# VICTORIAN CIVIL AND ADMINISTRATIVE TRIBUNAL

VCAT REFERENCE NOS. P510/2022 & P511/2022  
PERMIT APPLICATION NO. PLN/2021/616

<b>APPLICANT</b>	ID Ross Watt Road Pty Ltd
<b>RELEVANT AUTHORITY</b>	Macedon Ranges Shire Council
<b>REFERRAL AUTHORITIES</b>	Country Fire Authority Department of Education Department of Energy, Environment and Climate Action Department of Jobs, Skills, Industry and Regions Downer Tenix Environment Protection Authority Greater Western Water Head, Transport for Victoria Melbourne Water Corporation Powercor Southern Rural Water
<b>SUBJECT LAND</b>	89 Ross Watt Road GISBORNE VIC 3437
<b>HEARING TYPE</b>	Hearing
<b>DATE OF HEARING</b>	20, 21, 22, 23, 27, 28 & 29 March 2023
<b>DATE OF ORDER</b>	1 May 2023
<b>CITATION</b>	ID Ross Watt Road Pty Ltd v Macedon Ranges SC [2023] VCAT 471

#### Development Plan substituted

Figure 4: Overall subdivision layout plan. Source: DP p 33.

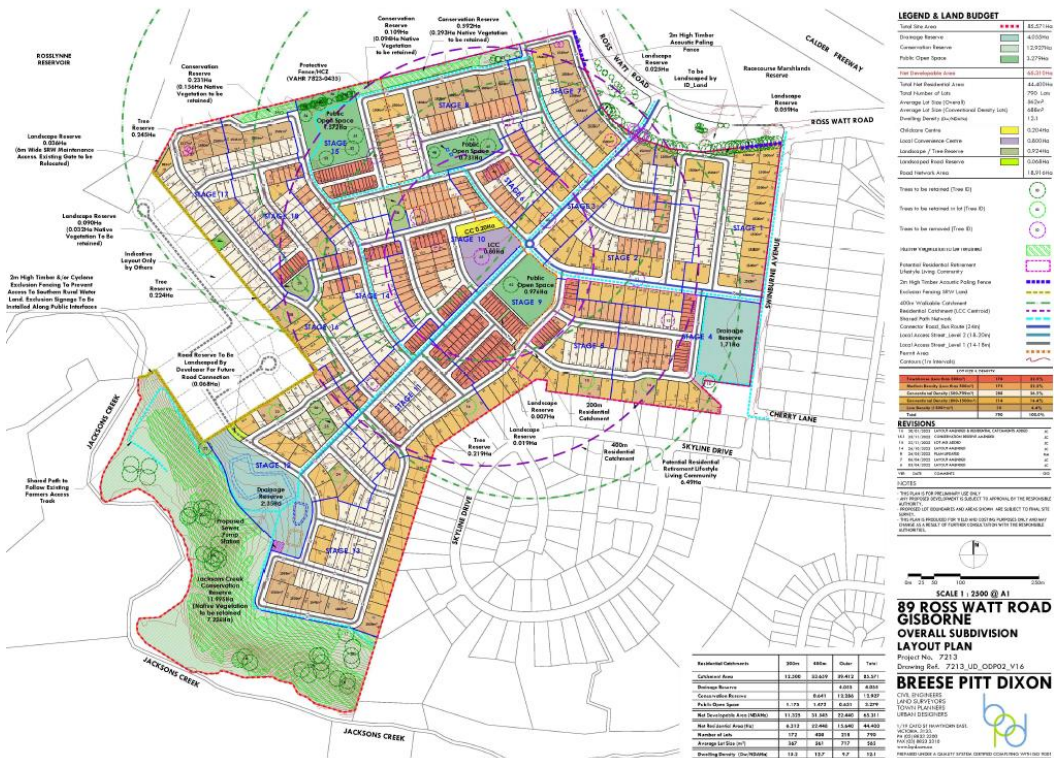
36 The DP includes a ‘proposed subdivision layout’ (PSL) as required by the planning scheme.<sup>18</sup> It is included in figure 4, below:

- 38 The legend to figure 4 also states the net residential area is 44.4 ha, the total number of (residential) lots is 790, the overall average lot size is 562 sqm, the average lot size of conventional density lots is 688 sqm and the dwelling density (dwellings per net developable area) is 12.1 per hectare.
- 39 The DP includes proposed social and physical infrastructure, stormwater management, movement network, indicative road cross sections, the landscape concepts (including street tree strategy and plans for reserves), and development sequencing.<sup>19</sup> I will only refer to these details if necessary in the consideration of the DP.
- 40 The DP must include a ‘conceptual urban design for the development of the Local Neighbourhood Activity Centre (approximate floor area of 500 sqm)’.<sup>20</sup> The DP includes a concept plan. See figure 6, below.

- 96 For the same reasons, six of the corner lots in this section are satisfactory. The townhouse lot is unsatisfactory and I will require this lot to be a conventional density lot, consistent with another change to which I refer in the next part of these reasons.

- 13 In section 4.1, amend Figure 4 to provide for a widened central road reserve of 24 metres and retention of the balance of land available for the local convenience centre and child care centre.
